35/13-05E 32 Quincy Street REVISION
Chevy Chase Historic District

SUBJECT: Historic Area Work Permit Application # 375130 **REVISION**

HISTORIC PRESERVATION COMMISSION STAFF REPORT

Address:	32 Quincy Street, Chevy Chase	Meeting Date:	04/20/05
Resource:	Contributing Resource Chevy Chase Village Historic District	Report Date:	04/13/05
Review:	HAWP	Public Notice:	04/06/05
Case Number:	35/13-05E REVISION	Tax Credit:	None
Applicant:	Steve and Diana Mysliwicz (Dan Law, Agent)	Staff:	Michele Oaks
Proposal:	Landscape Modifications		
Recommendation:	Approval with Condition

MYSLIWIEC RES.
 32 QUINCY ST
 CHEVY CHASE, MD (6)

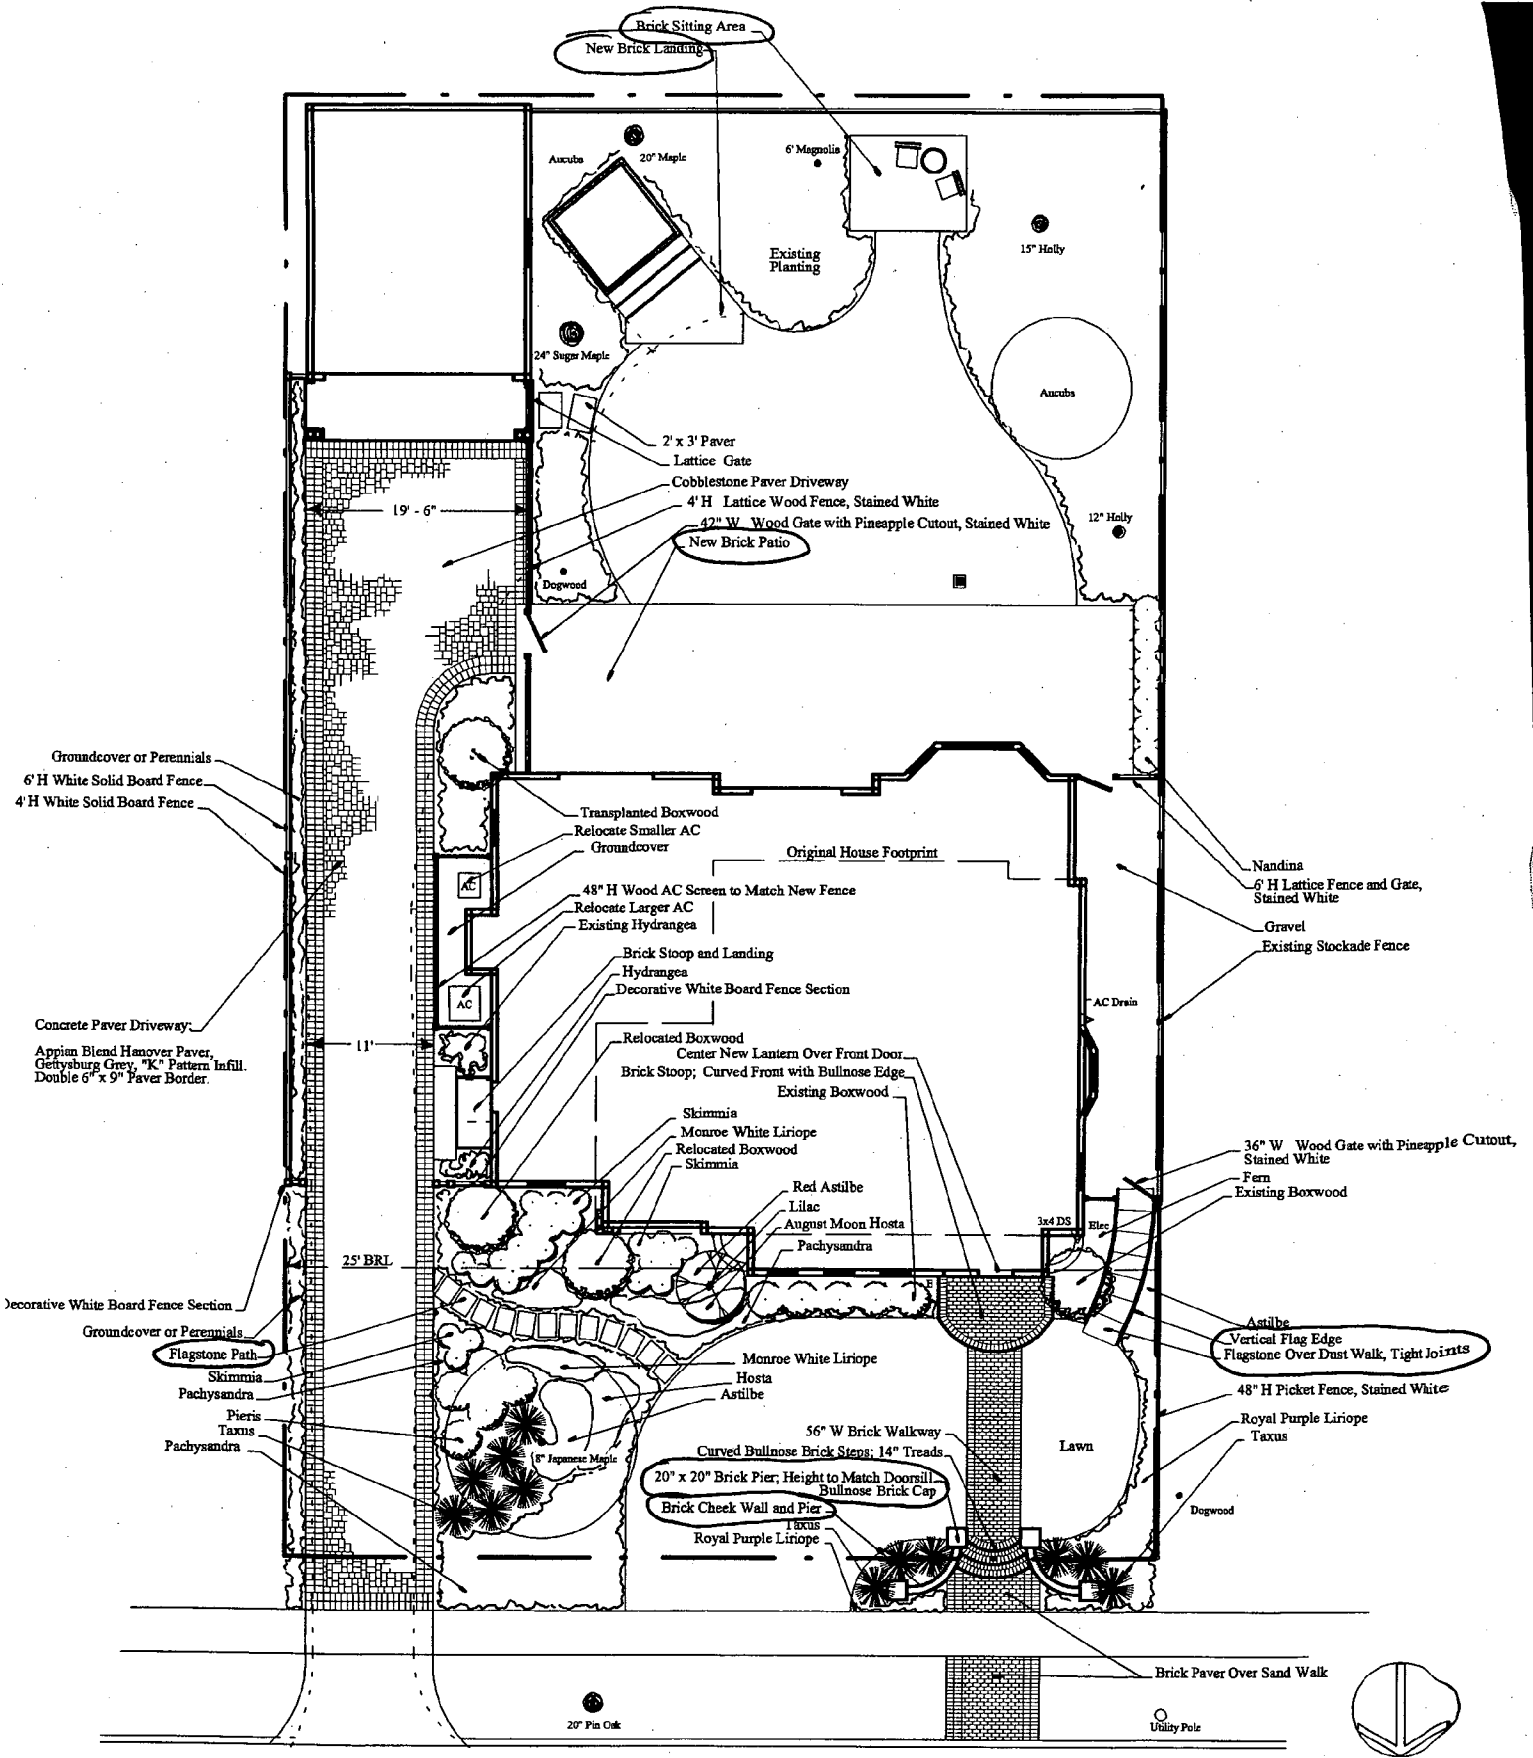
Staff feels that the proposed design meets the criteria outlined in the Chevy Chase Village Guidelines. Chevy Chase Village has reviewed the proposed plan and recommends that the Commission approve the concept of the front cheek walls, but build them at grade height, not the 15-18” above grade as proposed. Staff supports the Village’s recommendation.

The proposed cheek walls are built to grade.

- the proposed cheek walls are built to grade.
